The Shire @  
Old Ranch

Site Plan

March 5, 2020

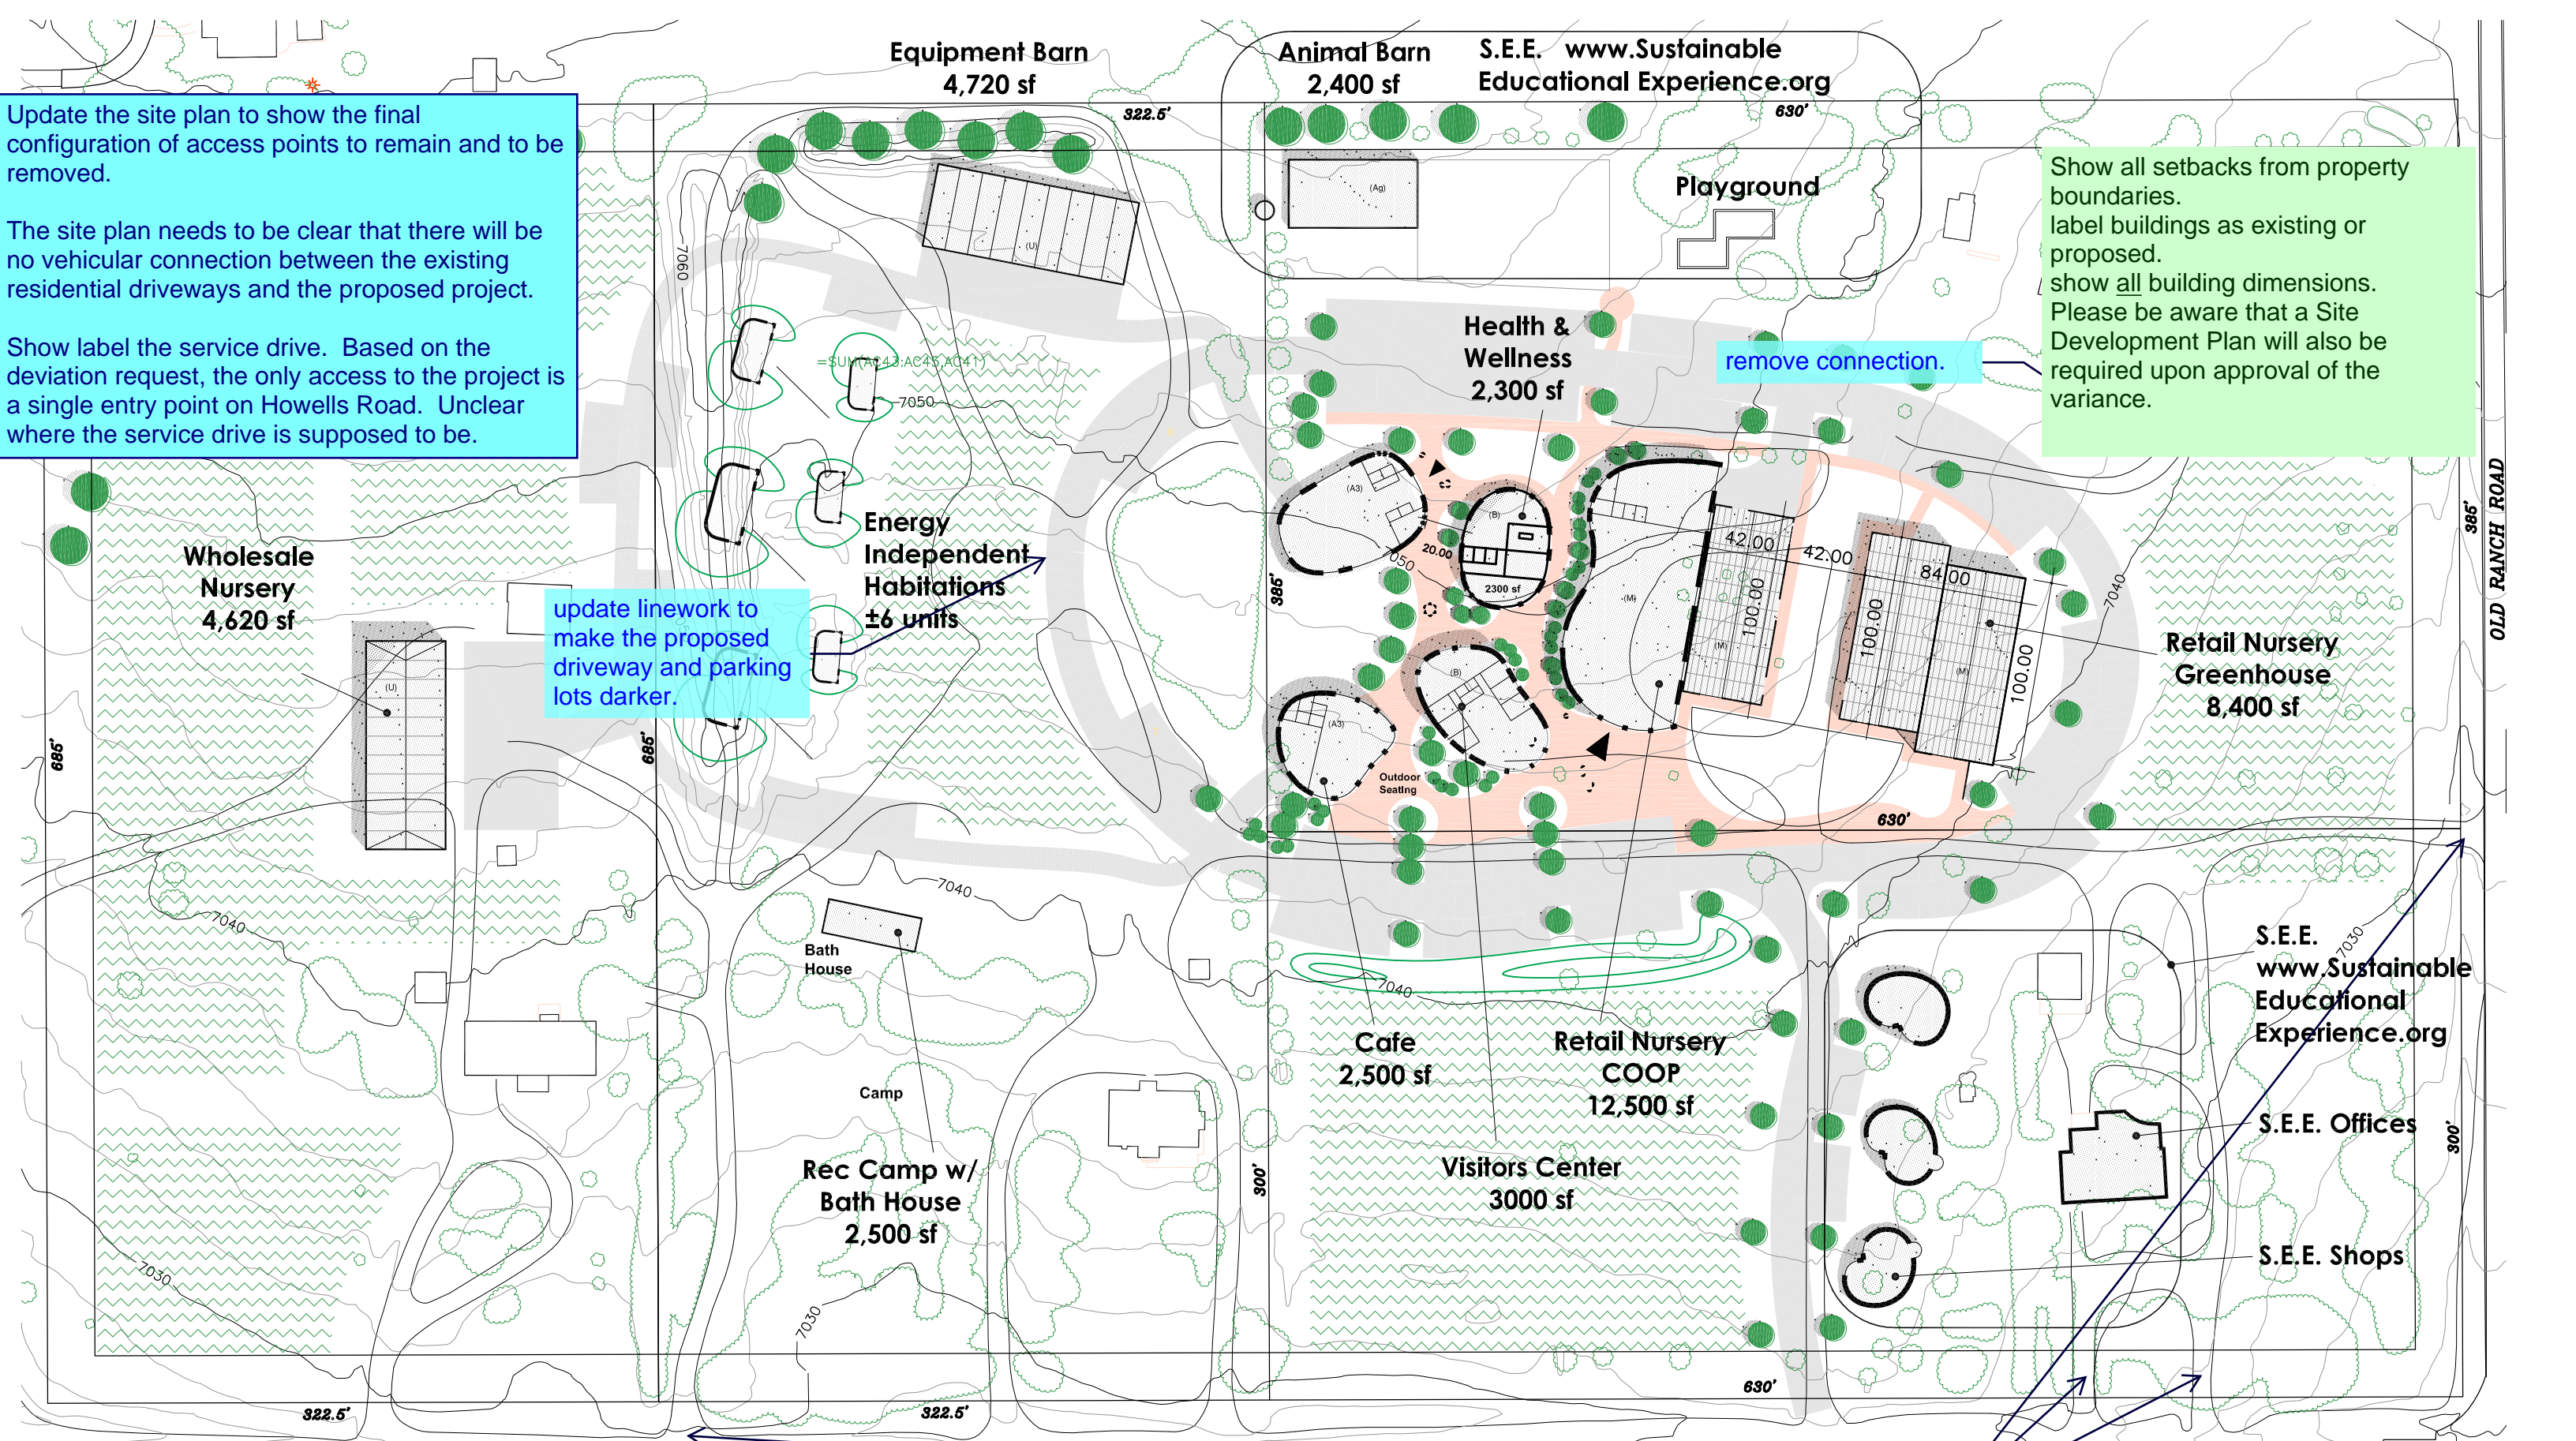
Update the site plan to show the final configuration of access points to remain and to be removed.

The site plan needs to be clear that there will be no vehicular connection between the existing residential driveways and the proposed project.

Show label the service drive. Based on the deviation request, the only access to the project is a single entry point on Howells Road. Unclear where the service drive is supposed to be.

Show all setbacks from property boundaries. label buildings as existing or proposed.

show all building dimensions. Please be aware that a Site Development Plan will also be required upon approval of the variance.

remove connection.

update linework to make the proposed driveway and parking lots darker.

remove driveway connections
